STAFF REPORT
COMMUNITY DEVELOPMENT DEPARTMENT

HEARING DATE: 7/19/2022
TO: Mayor & City Council
FROM: Joseph Dodson, Associate Planner
208-884-5533
SUBJECT: FP-2022-0011
Briar Ridge No. 1 Subdivision
LOCATION: The site is located on the west side of Meridian Road between W. Lake Hazel Road and W. Amity Road, directly south of the mid-mile point, in the NE ¼ of the SE ¼ of Section 36, Township 3N., Range 1W.

Final Plat request for 59 single-family residential building lots (24 townhome lots and 35 detached single-family lots) and 15 common lots on 14.14 acres of land in the TN-R zoning district, by Kent Brown Planning.

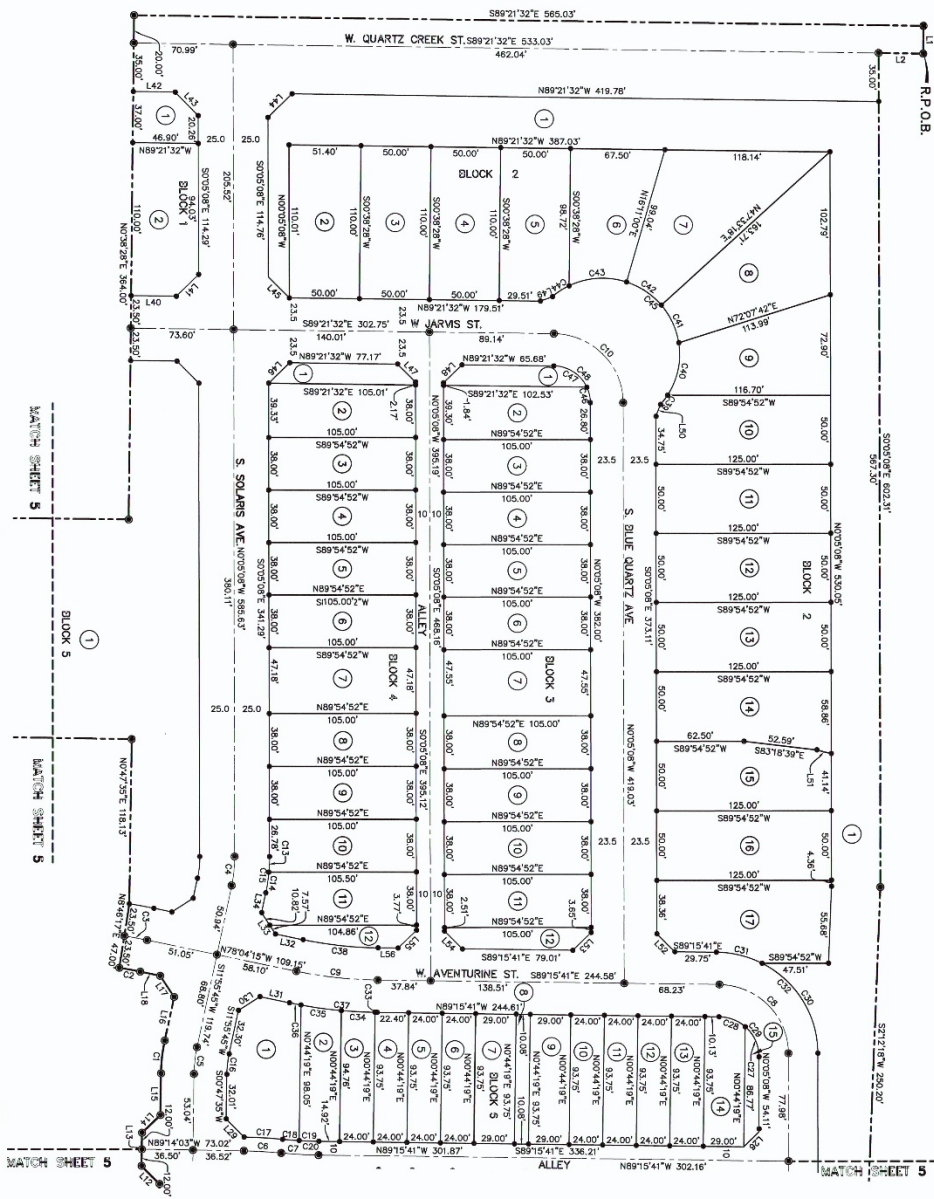
3. Prior to submittal for the City Engineer's signature, have the Certificate of Owners and the accompanying acknowledgement signed and notarized.
4. The final plat shown in Section V.B, prepared by Bailey Engineering, Inc., stamped on 02/25/22 by Cody M. McCammon, is approved with the following conditions to be completed at the time of Final Plat Signature submittal:

- a. Note #10: Include recorded instrument number.
 - b. Note #11: Include recorded instrument number.
 - c. Note #12: Include recorded instrument number.

- d. Add a plat note stating "Development is subject to all provisions contained within the recorded Development Agreement (DA Inst. #2021-161803).
 - e. Add a plat note regarding the recorded Meridian Pathway Easement and note the encumbered common lot(s).

D. Emergency Access Exhibit

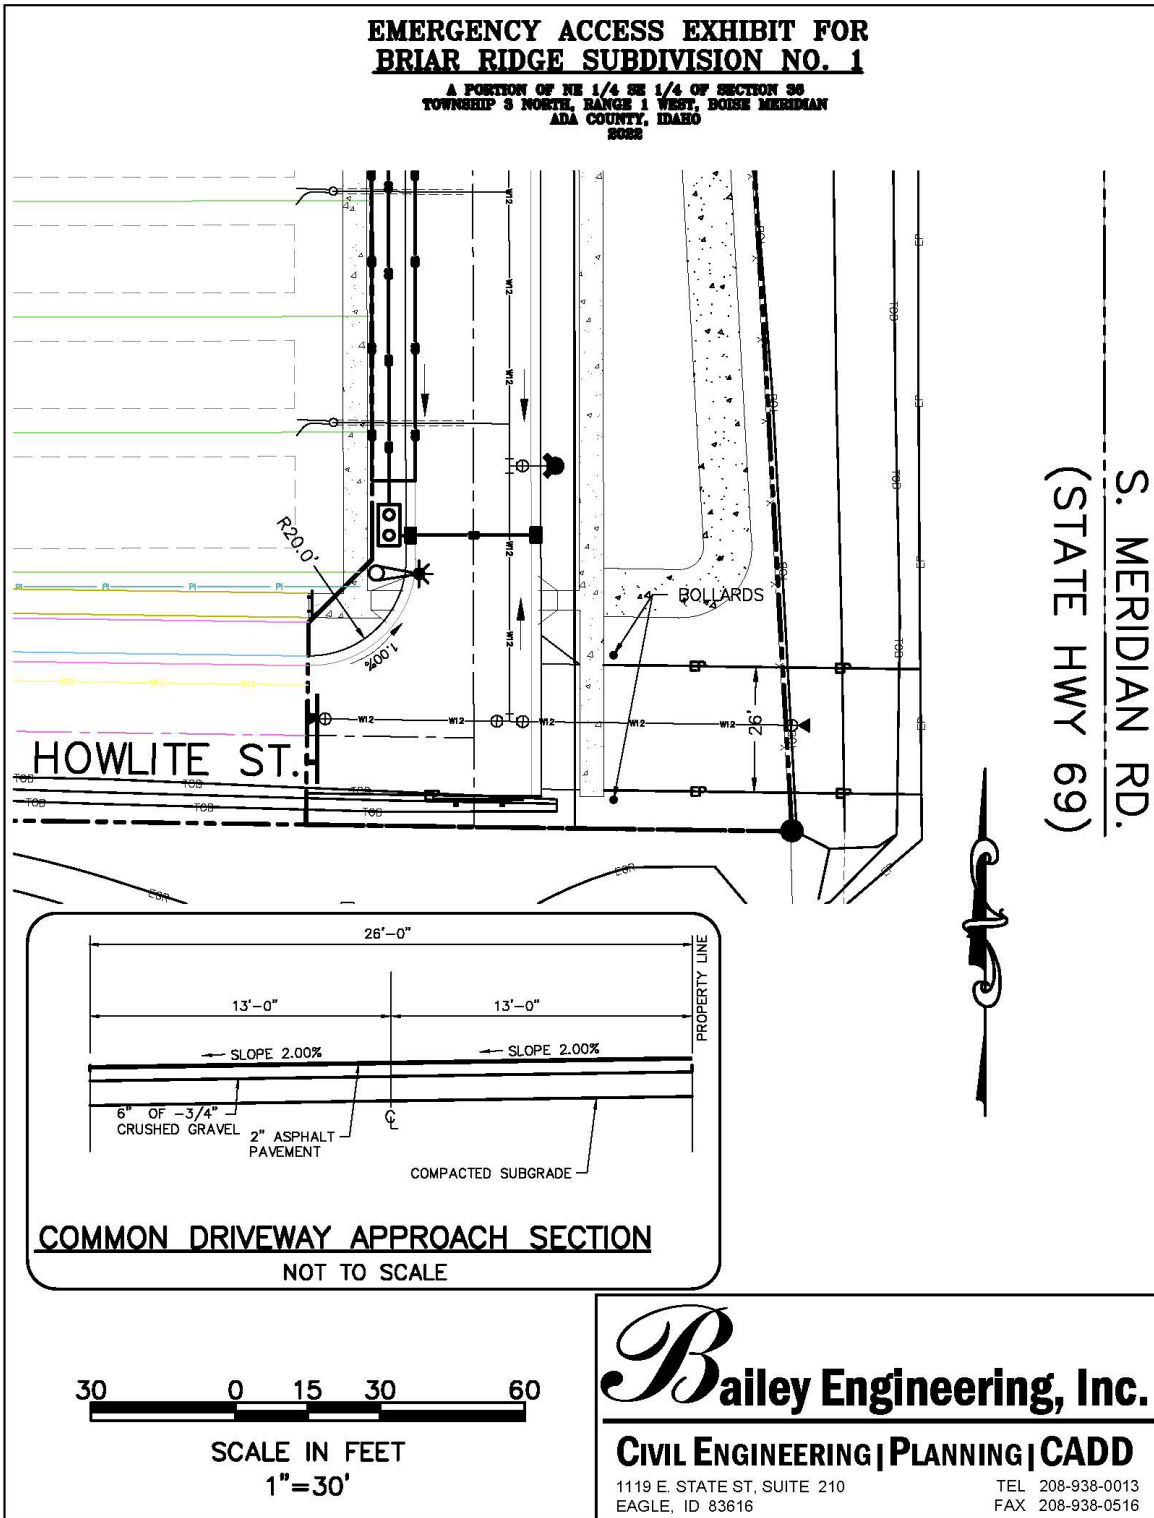
5. The Landscape Plan shown in Section V.C prepared by Bailey Engineering, Inc., dated 12/20/2021, is approved as submitted.
6. Prior to City Engineer signature on this final plat, revise the Emergency Access Exhibit (Exhibit V.D) to include enough bollards to keep the public from utilizing this access (exhibit appears to show two (2) bollards alongside the access drive but none preventing the public from utilizing access).
